From: [REDACTED]
To: [Legislative Services Shared](#)
Cc: [Jessica Anderson](#)
Subject: [EXTERNAL] - BYLAW C-8031-2020 North Springbank Area Structure Plan
Date: January 29, 2021 12:07:28 AM

North Springbank ASP (fall 2020 draft) SECTION 20 UTILITY SERVICES

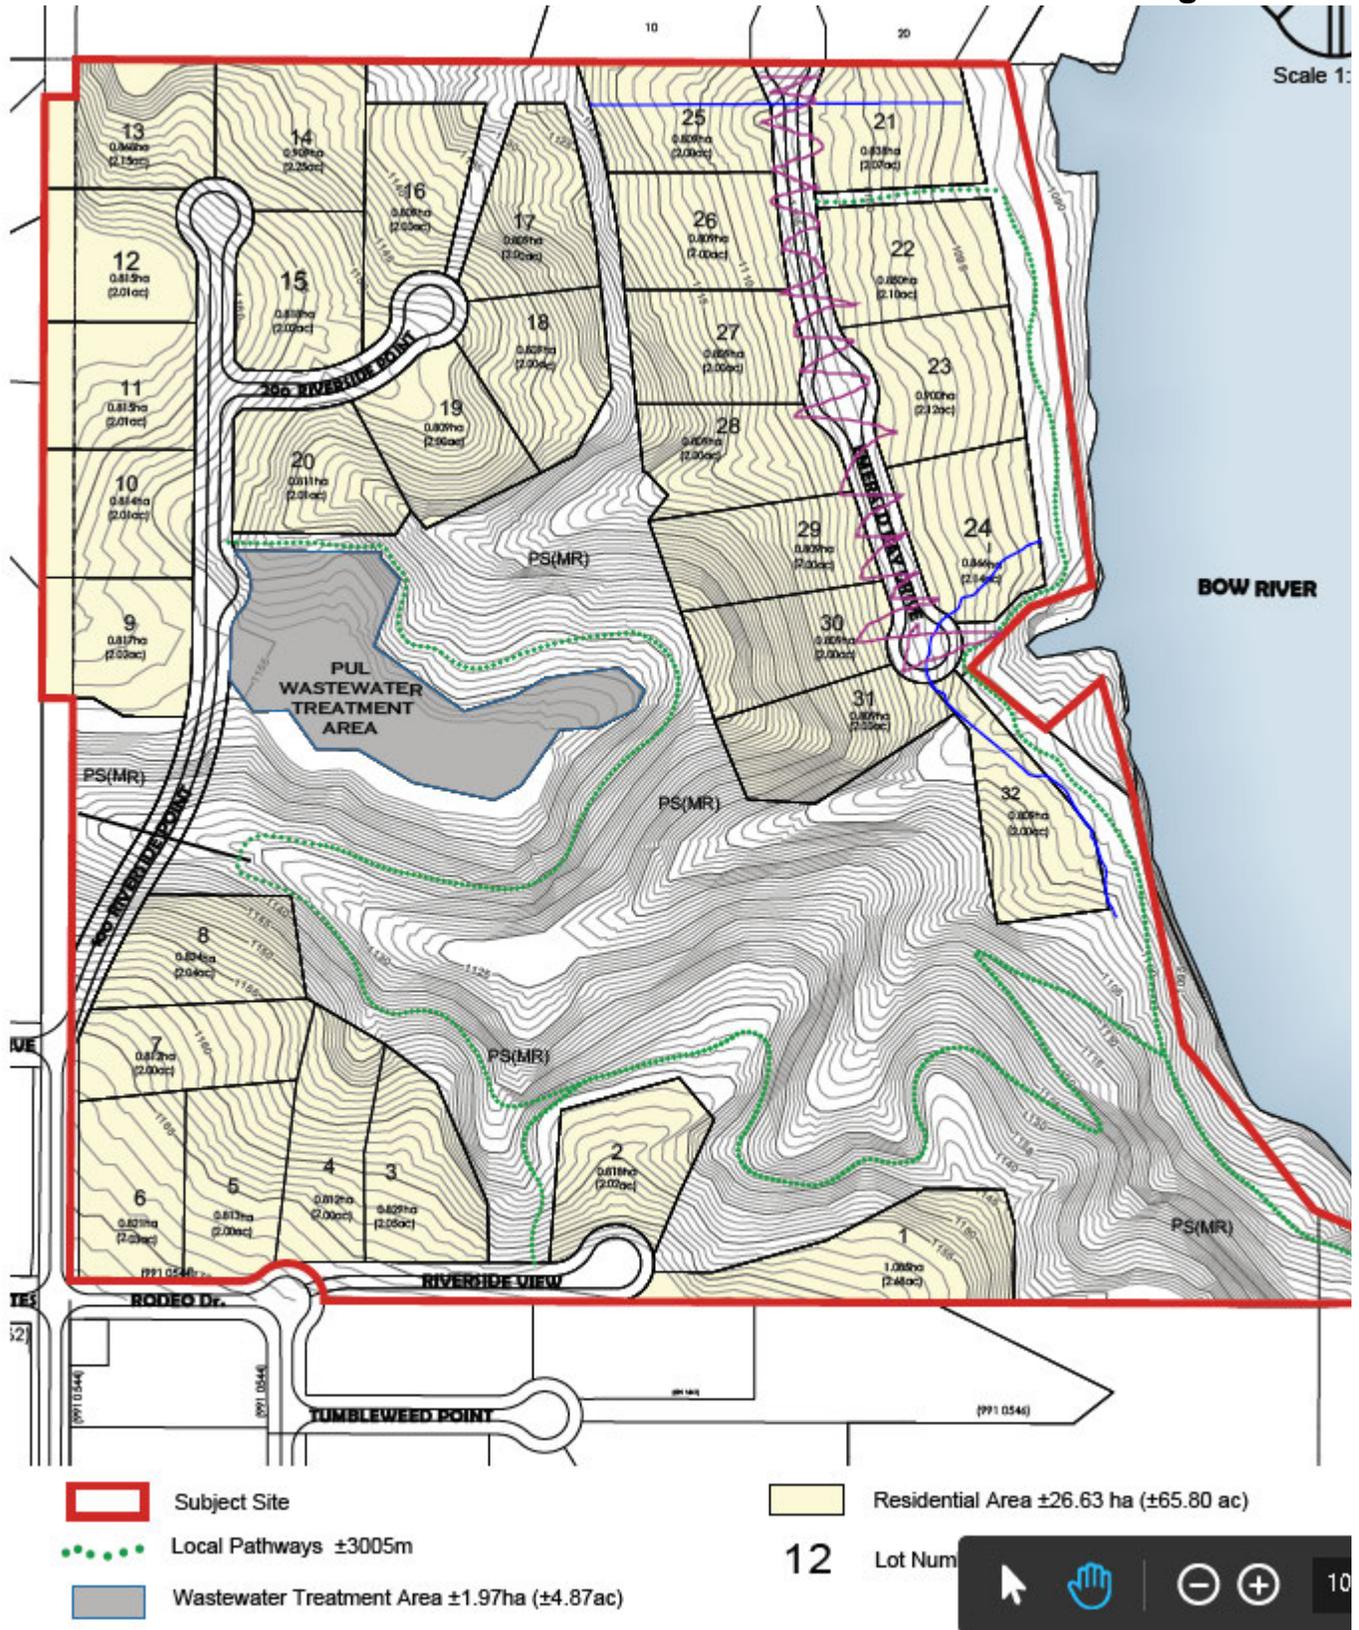
1. Pathway relocation away from the Reservoir:
 - a. Incompatible with Wildlife Corridors: The pathway located along the water in Emerald Bay and the future Riverside Estates development along the Bearspaw reservoir should be moved to be along Emerald Bay Drive, in order to protect the Environmental Reserve and the wildlife corridor and should not have pedestrian pathways (with people, dogs and other pets) located on the ER and wildlife corridors as same will interfere with the wildlife corridor. See further illustration below on this topic in relation to Section 7.22 of the North Springbank Area Structure.

- b. Public Pathway/Dog Park along Reservoir Unacceptable Risk to Water Source: Also, the proposed publicly accessible pathway along the reservoir would essentially become a "dog park", particularly given the burgeoning population and development in the area and such close proximity to a city as large as Calgary, and fecal matter from dogs and pets is a major concern for water quality, as noted in the Bearspaw Reservoir Trilateral Task Report. This is another reason these pathways should not be along the reservoir.

MAP 2

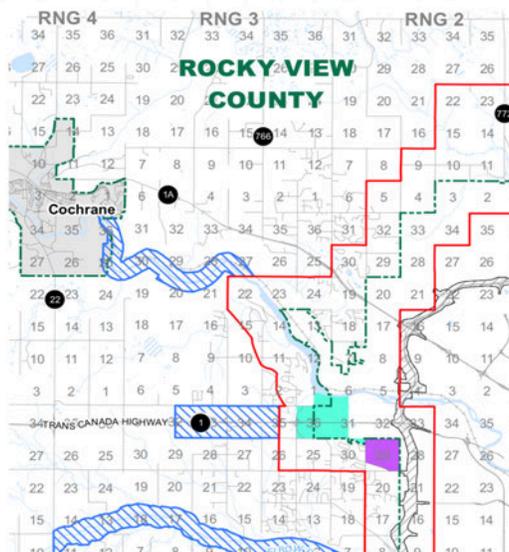
- Please note also that the Intermunicipal Development Plan the Highway 1 West Corridor Key Focus Area does **not** include **NW25 and NE25** - the 1/2 Section south of Township Road 245. See the map below where the teal blue Highway 1 West Corridor includes Section 36, but no land in Section 25 south of the teal blue area. The land in Section 25 is not adjacent to the interchange and its addition to the Urban Interface is not consistent with the Intermunicipal Development Plan.

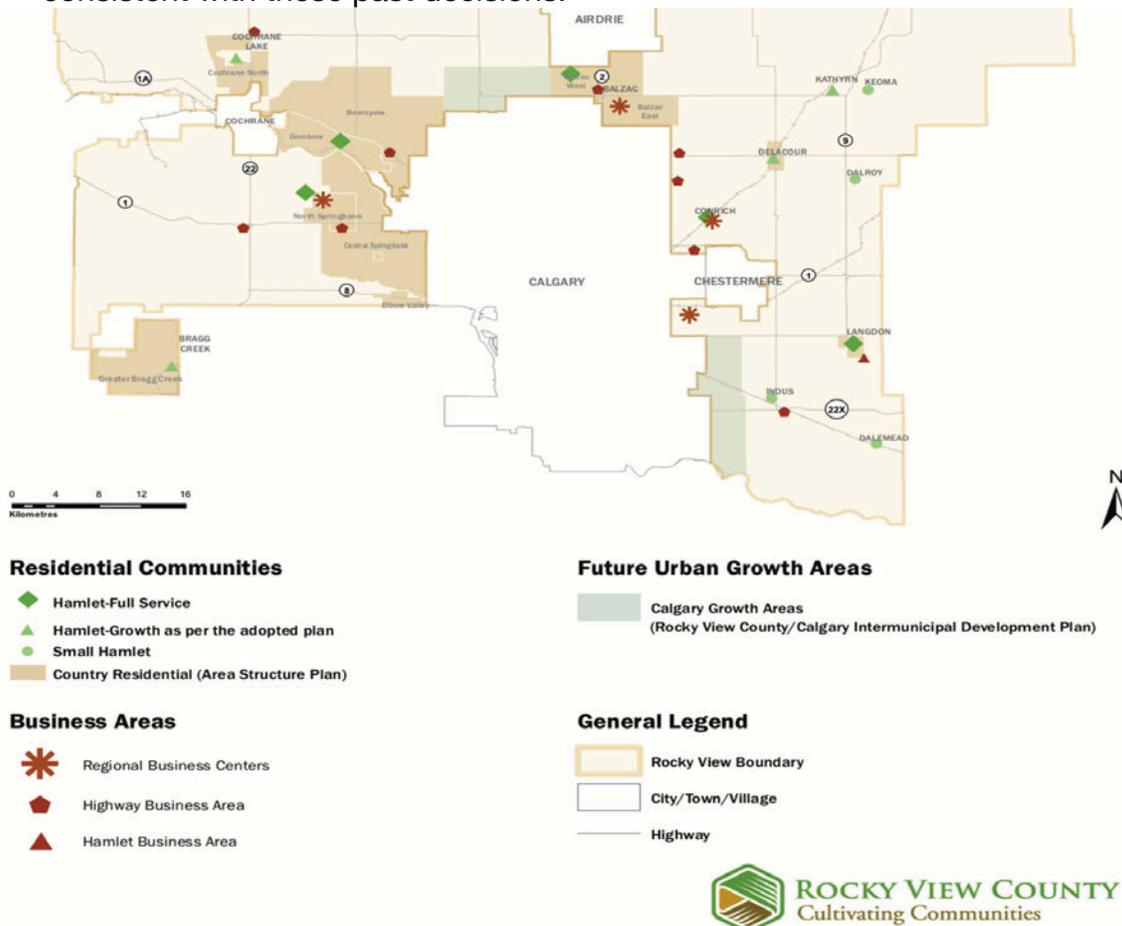
- Map 1 on page 26 shows these and notes that these “*are of limited size and should be located in proximity to highway intersections and interchanges.*” The Urban Interface in the draft North ASP is four quarters which I believe is not of limited size. It also includes the two quarters NW25 and NE25 which are not adjacent to the interchange.

- In fact, if you look carefully at the map the County Plan does **not** include a Highway Business Area on the Old Banff Coach Road interchange. There is one at the Range Road 33 turnoff, but not along the Old Banff Coach Road (a.k.a. Range Road 31) turnoff.

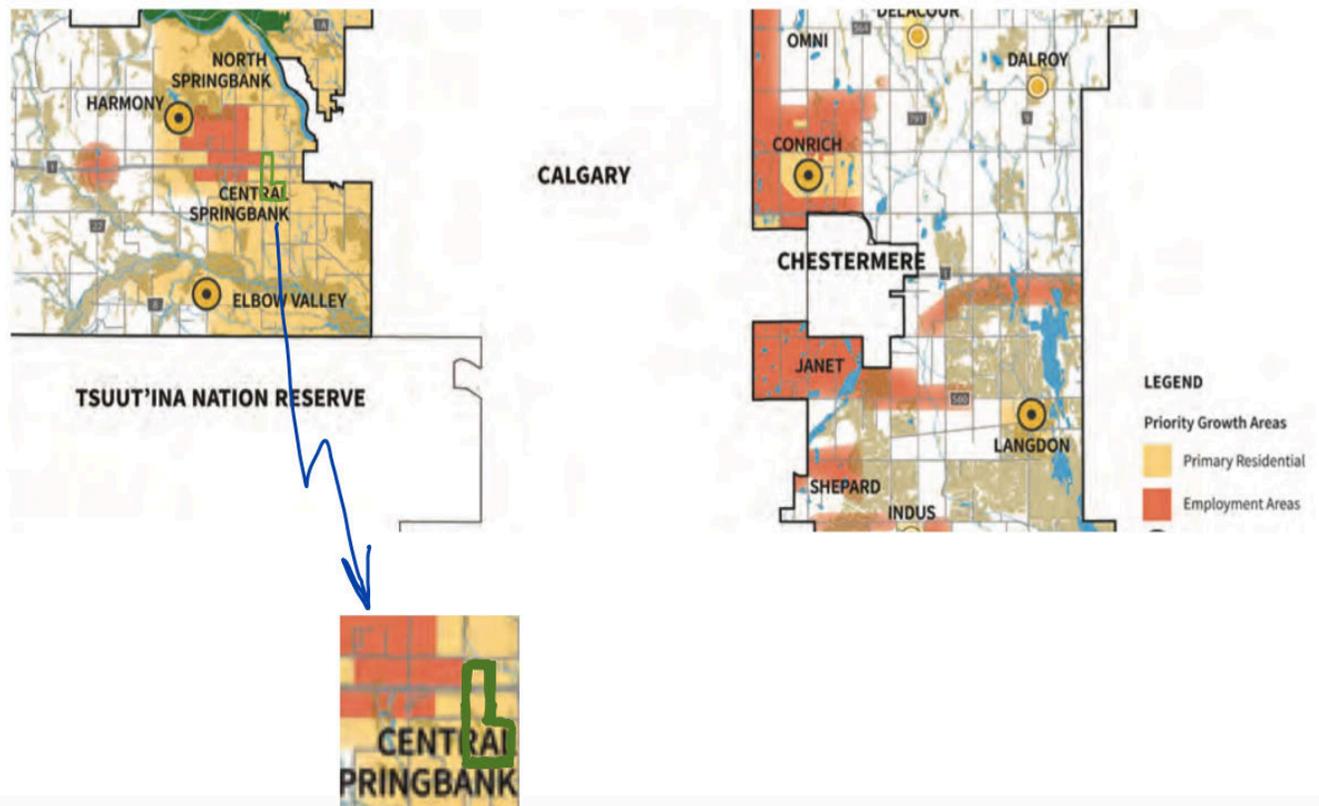
- The map below is small, but when zooming in you'll see that the Priority Employment areas in dark orange are outside the proposed Urban Interface in the draft North ASP. I have drawn the Urban Interface area in green.
- Again, I would urge the removal of commercial zoning in the areas draft North ASP zone as Urban Interface so that these documents are consistent.

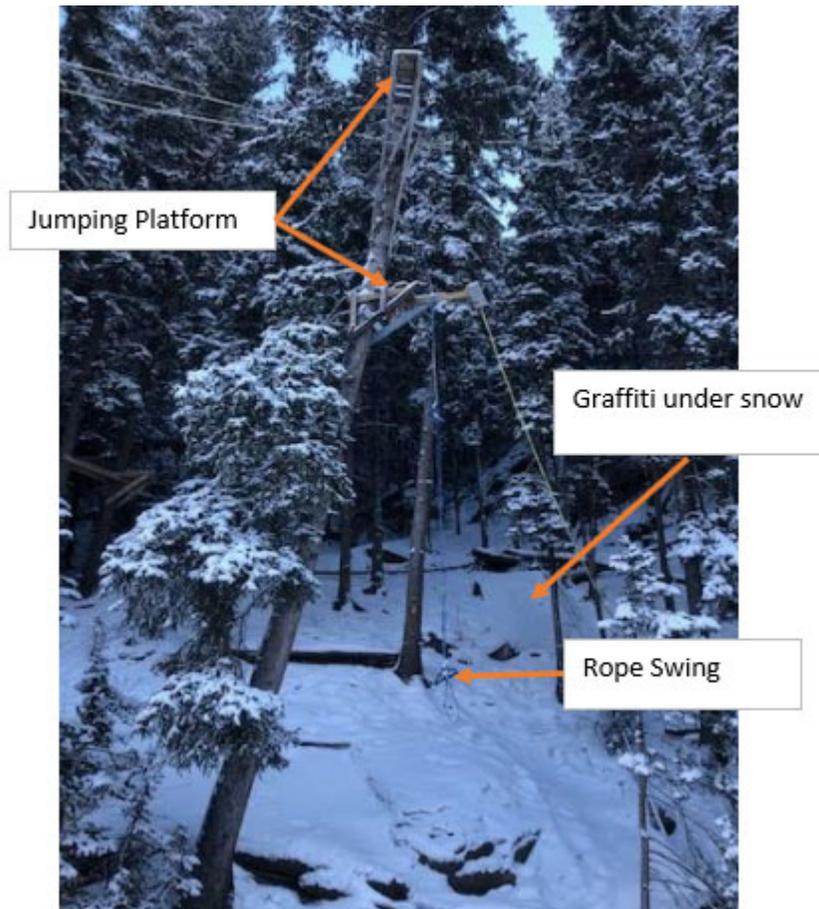
**Un-managed excessive and illegal parking on the roads.**

Adding a pathway will draw attention to the cove north of Springbank links golf course as well as the south cove by the dam. These areas have been quiet coves for decades until this summer, when kids discovered this north cove as a part of Calgary parks. Cars were parked along the road making it very dangerous for other vehicles and cyclists. As a cyclist myself, I was in a dangerous situation trying to navigate the parked cars and flowing traffic passing me. Had one of the parked cars opened their door at the point of passing, I would not have had the opportunity to navigate around. By allowing a pathway along the reservoir, there will be a significant amount of increased illegal parking on Emerald Bay Drive and accessing the reservoir.

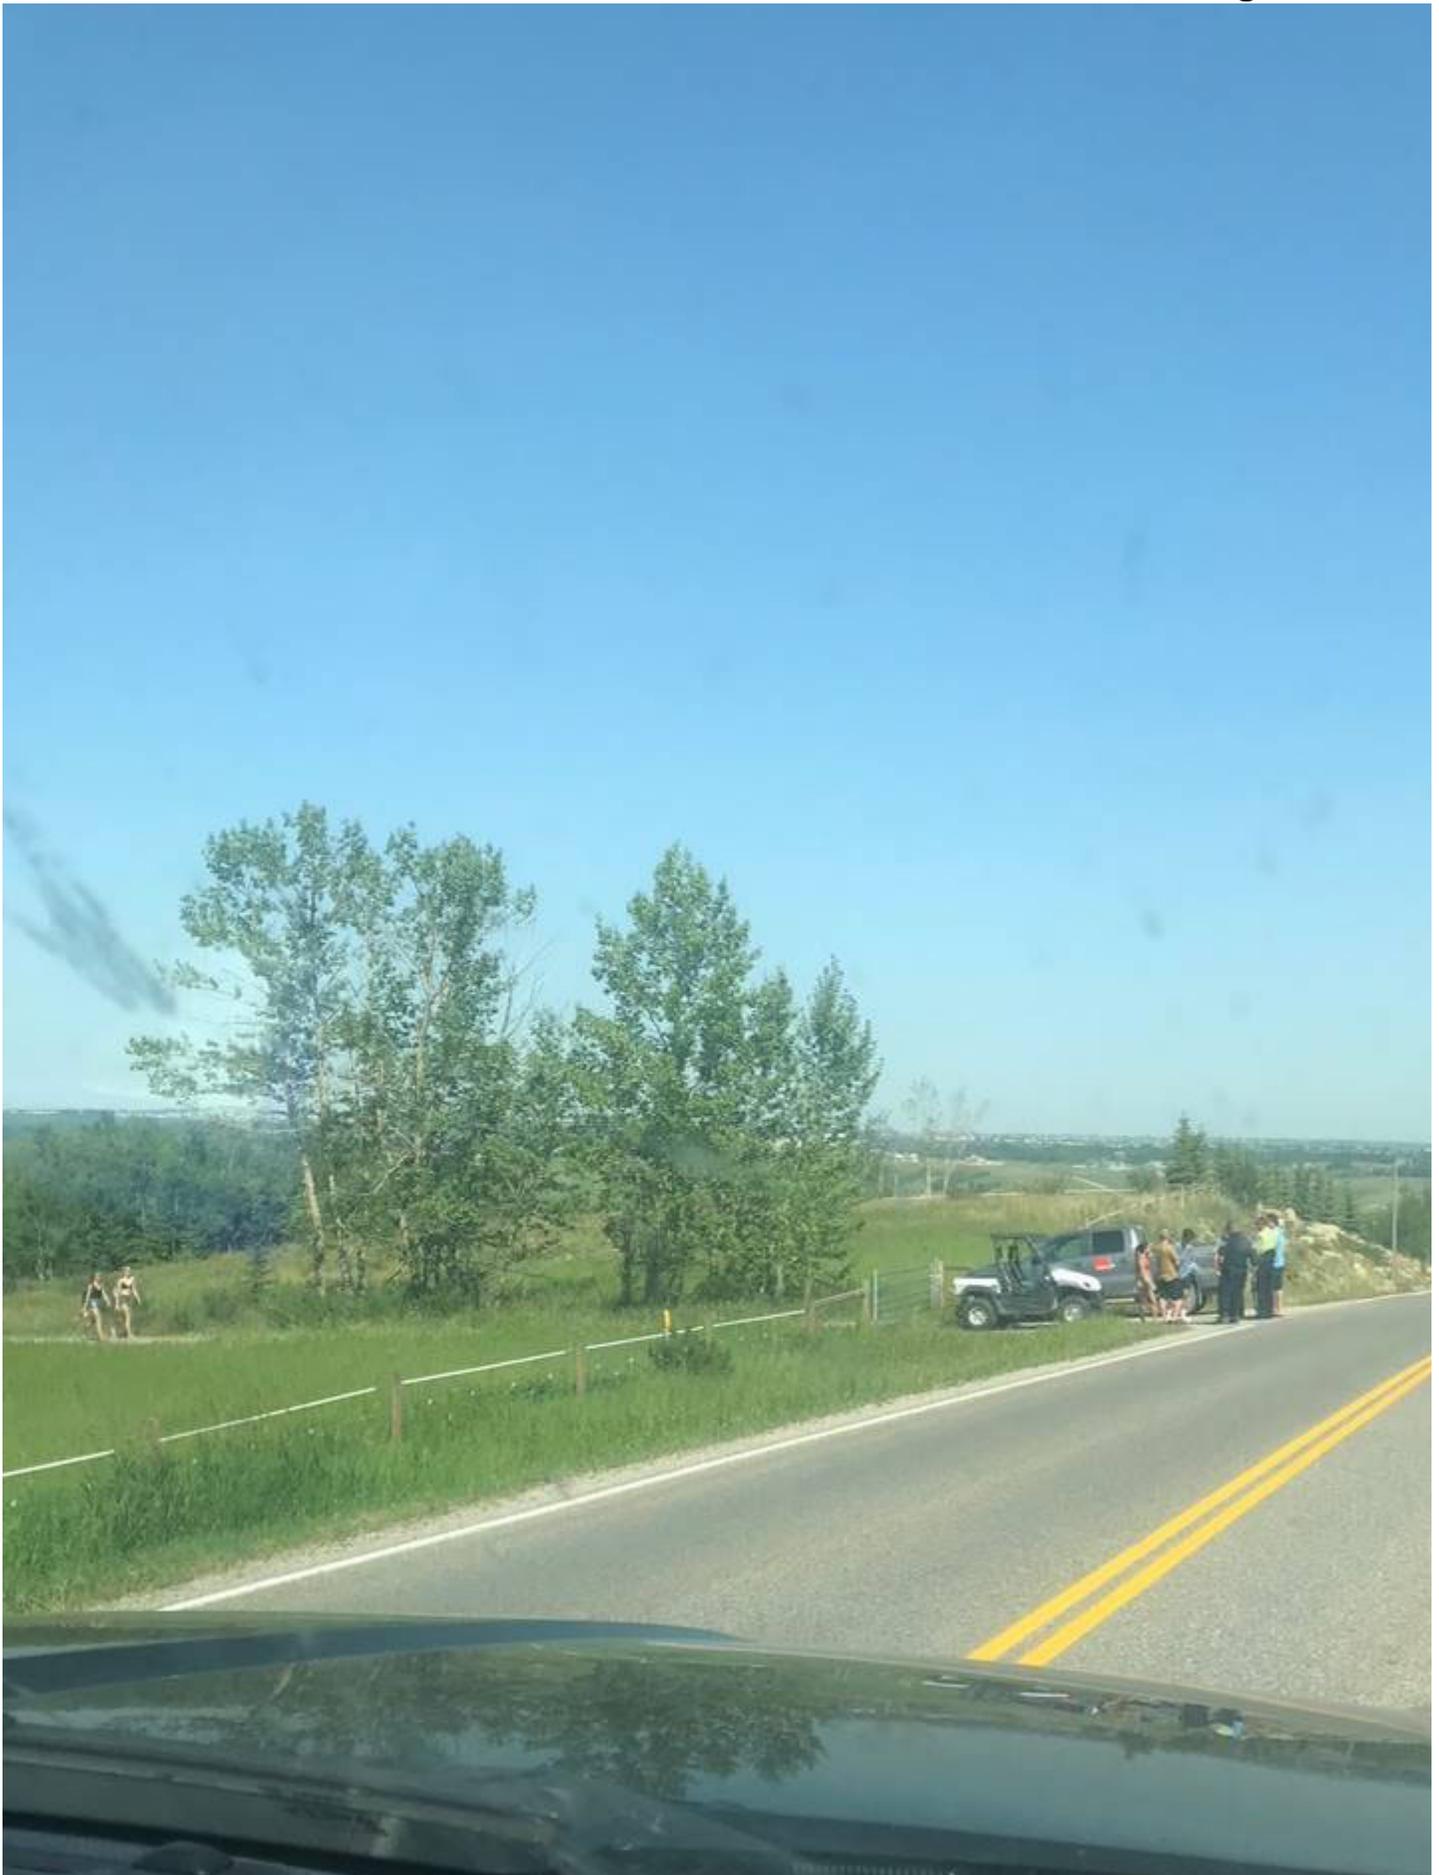
Below are further photos of the parking problems along Springbank Links club house due to the pedestrian access to the Reservoir, before it was shut down. Note the three police vehicles, their enforcement efforts made a very small dint in the problem that day, but the crowds were back as soon as they left and overall it was completely ineffective in managing the problem, which lead to the City shutting down the access, that was the only way to solve it.

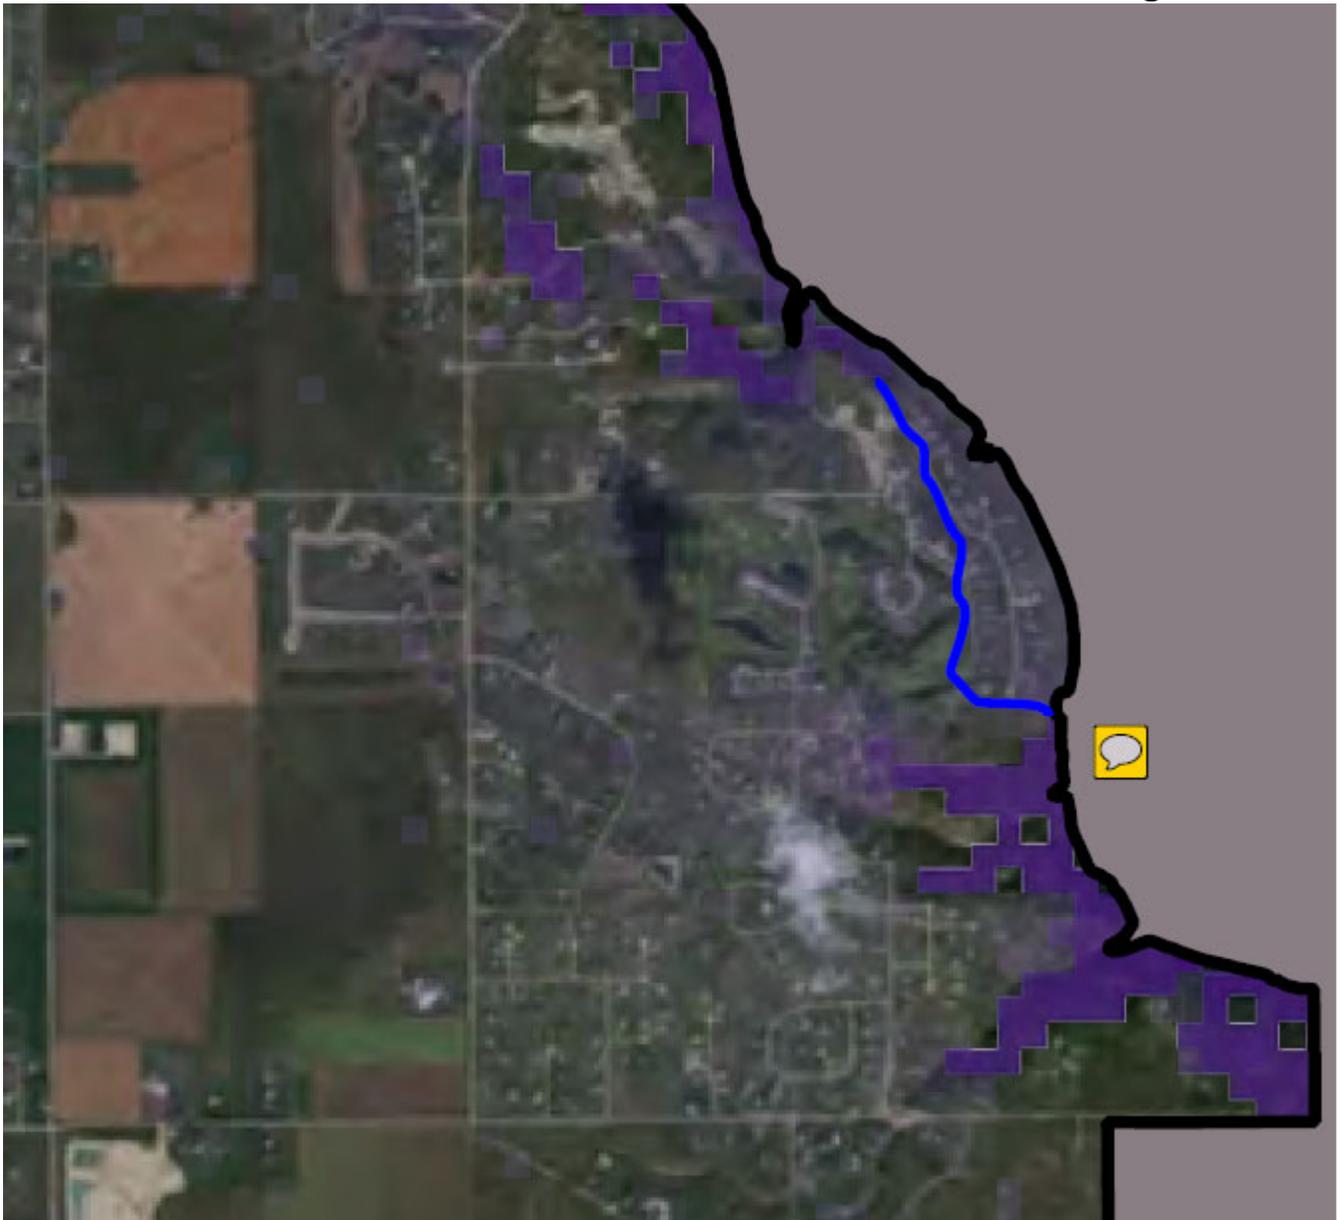
Below is a snip of Figure B2 Wildlife Habitat Connectivity Model Moose. I have hand drawn in blue the wildlife corridor that exists – we know because we often have moose travelling it through our backyard. I will send further and hopefully better illustrations. I have photos of the heavy wildlife trails, can I send them to your mobile, if so what is your mobile #?
